ADDITIONAL NOTES PER MOUNT ZION LETTER DATED MAY 19 2006:

**FOR PUBLIC HEARING
PETITION NUMBER 2006-66**

SITE PLAN
SCALE: 1" = 20'

SITE PLAN FOR
MT. ZION PROPERTIES, LLC.
6010 E. W.T. HARRIS BLVD.
CHARLOTTE, NC.

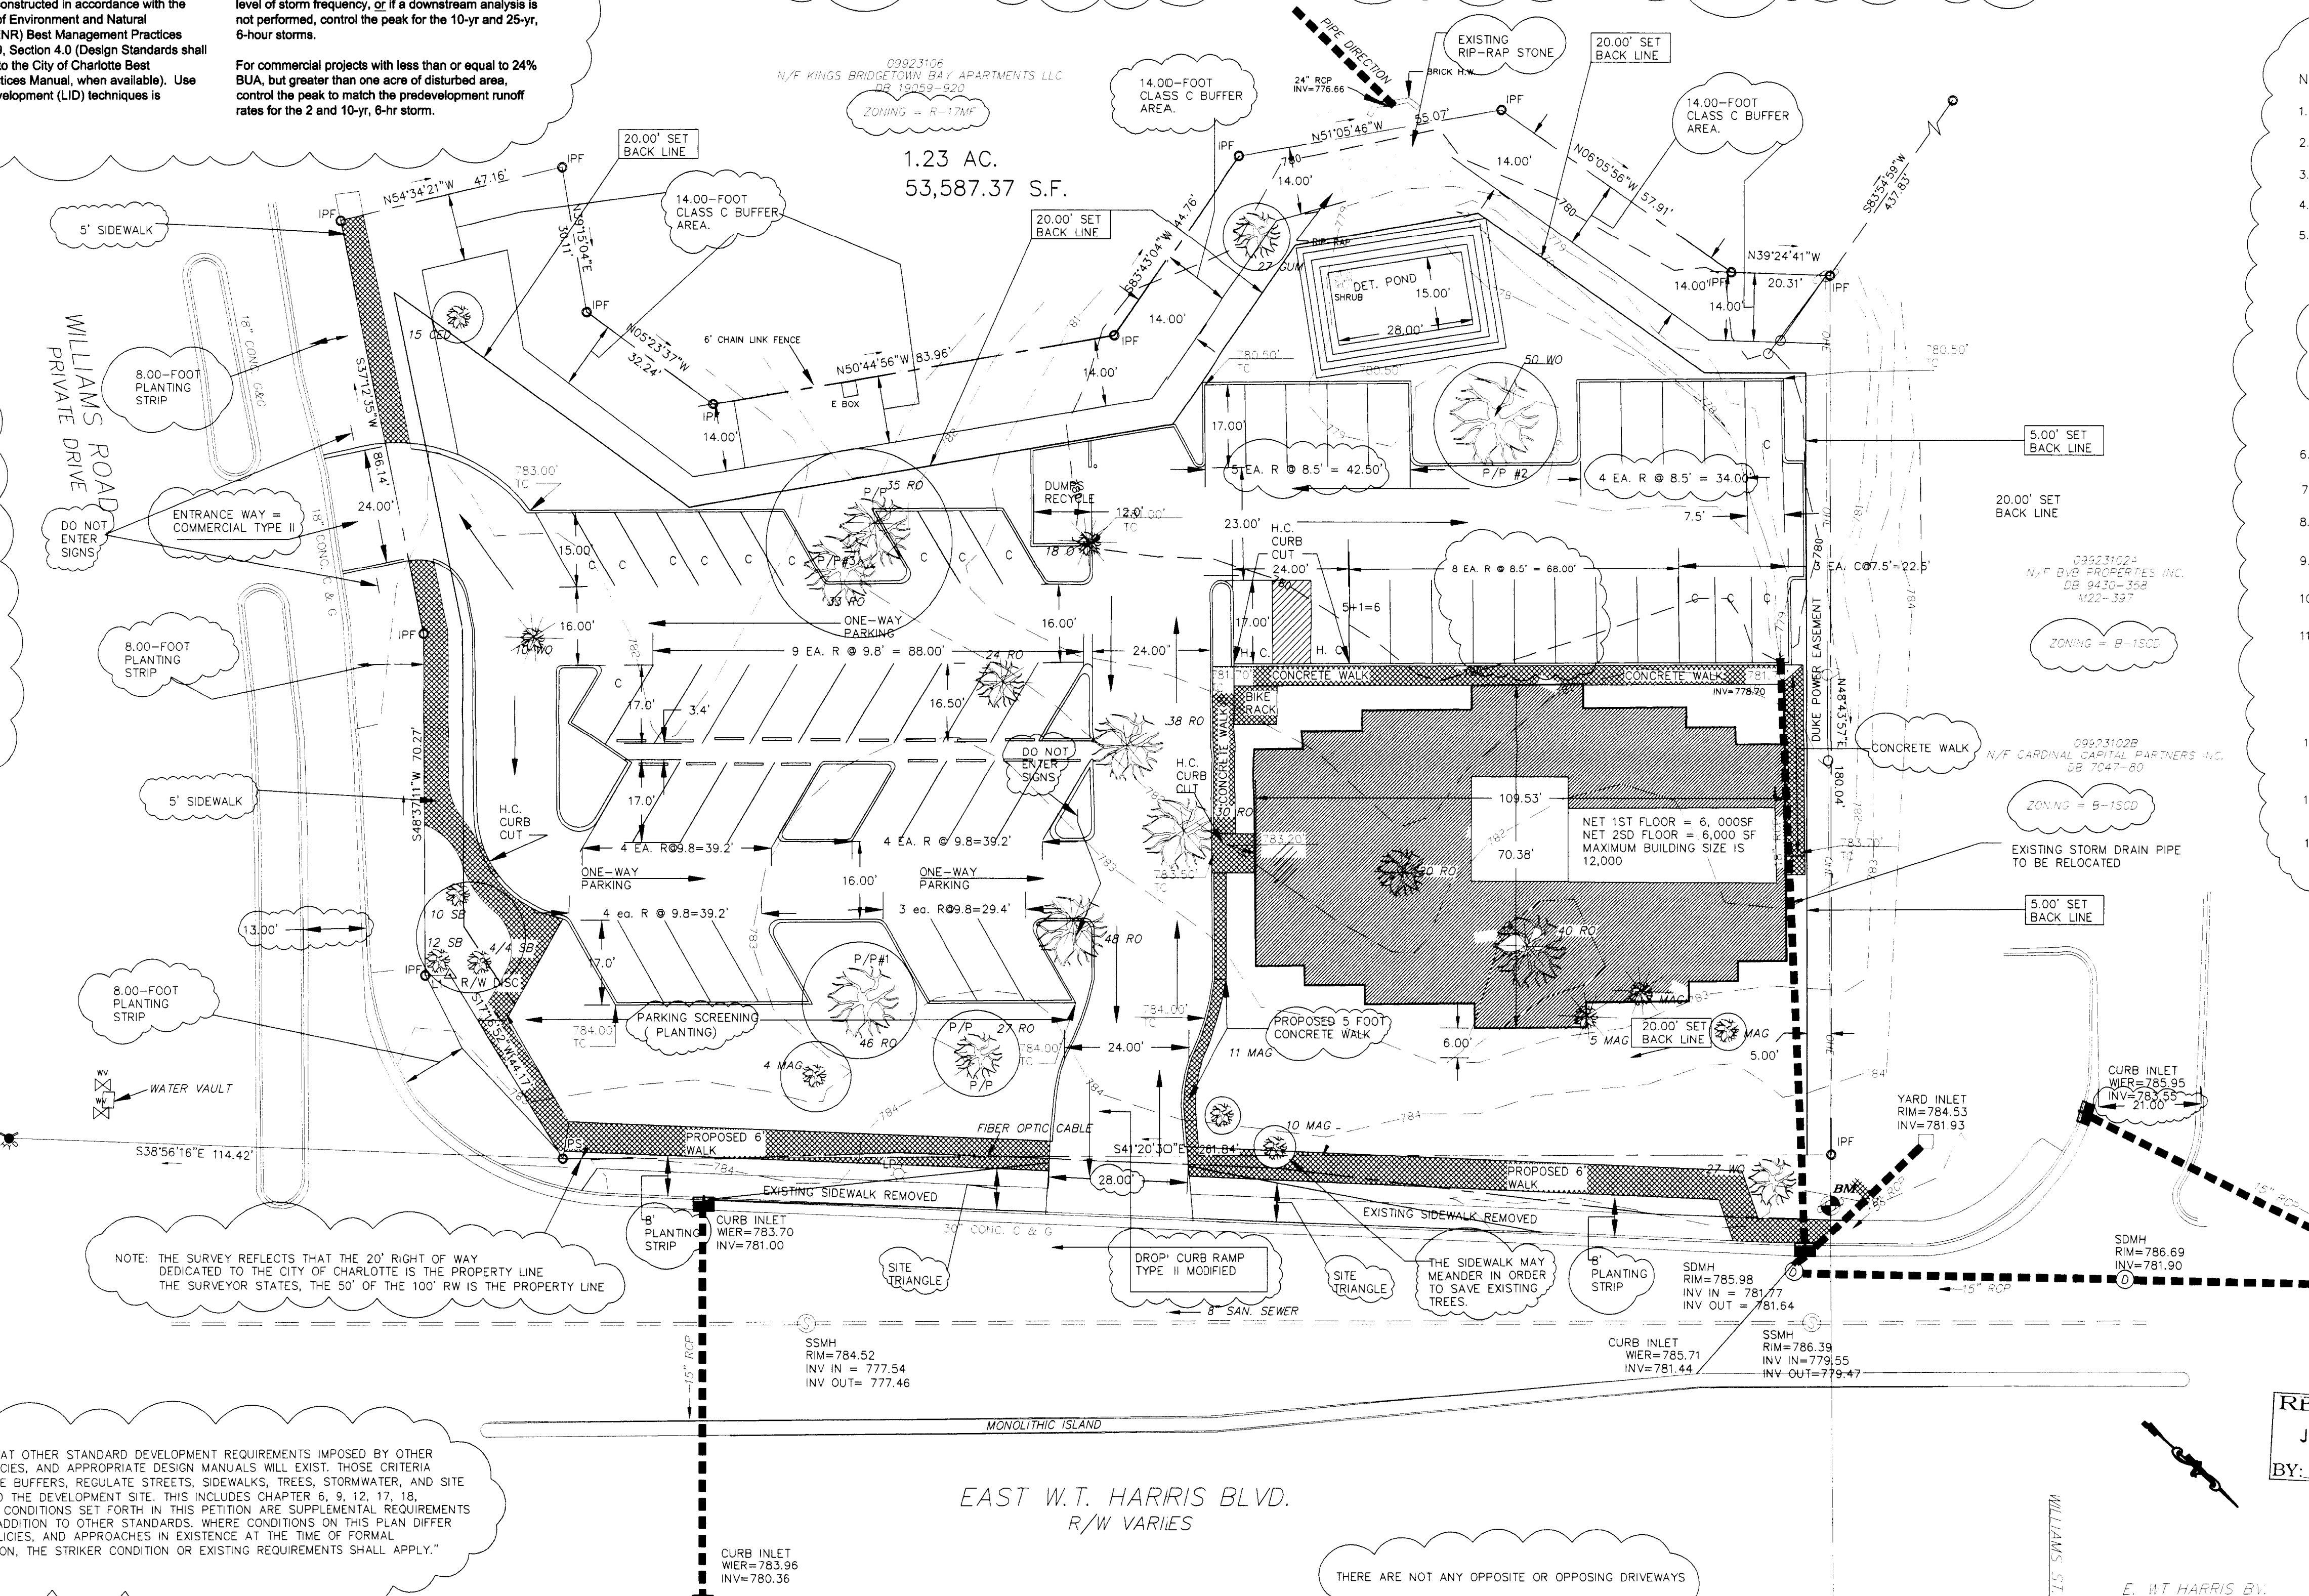
- THE BUILDING ELEVATION SHALL BE FACE BRICK WITH STUCCO TRIM AS SHOWN ON THE SUBMITTED ELEVATION PLAN.
- MOUNT ZION PROPERTIES IS WILLING TO CONSIDER SAVING ADDITIONAL TREES, HOWEVER, REQUEST THAT ADDITIONAL PARKING SPACES BE REDUCE TO SATISFY THE ROOT ZONE REQUIREMENTS.

- THE 33" R. O. TREE IS SHOWN TO BE REMOVED.
- THE DENTENTION POND HAS BEEN ROTATED AND MOVED AS SHOWN. 2 EACH ADDITIONAL PARKING SPACES ARE SHOWN.
- THE TREE ISLAND BEHIND THE BUILDING IS OMITED AND 2 EACH PARKING SPACE ARE SHOWN.

- THE WHITE OAK IS NOW SHOWN TO BE REMOVED.
- THE 14' CLASS C BUFFER IS OMITED AND NOW SHOWS THE 8-FOOT PLANT STRIP BETWEEN THE SIDE WALK AND CURB, ALONG WILLIAMS ROAD.

- EXISTING NOTE 11 & 12 IS REVISED TO SHOW HOW THE EXISTING TREES WILL BE PROTECTED.
- THE LETTER TO THE PLANNING COMMISSION, REQUESTING THREE PARKING SPACE REDUCTION WAS SUBMITTED ON MAY 3, 2006.

- THE MAXIMUM BUILDING HEIGHT IS SHOWN ON NOTE 14.
